**Question concerning the sun load impact (phantom effect)
of the signalling lamp Regulation [LSD] of Paragraphs 5.5 and 5.6**

1 Proposal

Figure 1 Typical arrangement for the measurement of the luminance produced by the sun load impact (phantom effect) .

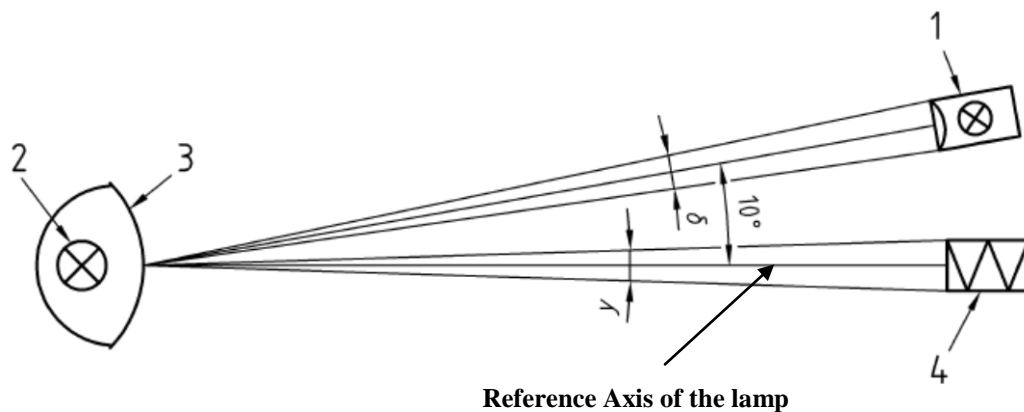
ANNEX 8 Measurement of the sun load impact

The light source generating a sun load impact according to Figure 1 below is a projector with a light source of a correlated colour temperature between 4500 K and 6500K.

The light from the projector shall illuminate at least the light emitting surface of the optical unit with the illuminance $E = 40\ 000\ \text{lx}$ and uniformity (inside the area of the light emitting surface) of 10 %.

The reference axis of the lamp and the axis of the projector shall form an vertical angle of 10° .

The plane formed from both axes shall be the operational vertical plane. The arrangement shall be in a way that the projector radiates the light as if from above the signalling lamp.

If the illuminance E_1 on the light emitting surface of the lamp cannot be realized the illuminance of $E = 40\ 000\ \text{lx}$ for the sun load impact (phantom effect) , the luminance L_{ph} can also be calculated for the lower illuminances E_1 from the measured lower luminance L_{phl} :

$$L_{ph} = L_{phl} \times \frac{40000\text{lx}}{E_1}$$

However, the illuminance E_1 shall be not lower than 10000lx .

Measurements of sun load impact (phantom effect) depends strongly on the geometry of measurement. The recommended distance for measurements for obtaining comparable results is 10m.

A shorter distance is allowed as long the required uniformity of the illumination by the projector as well as all other required parameters as specified in this Annex are met and the use instruction of the measuring head allows it.

The measuring head to determine the luminance shall be placed so that the reference axis of the lamp and the axis of the measuring head coincide.
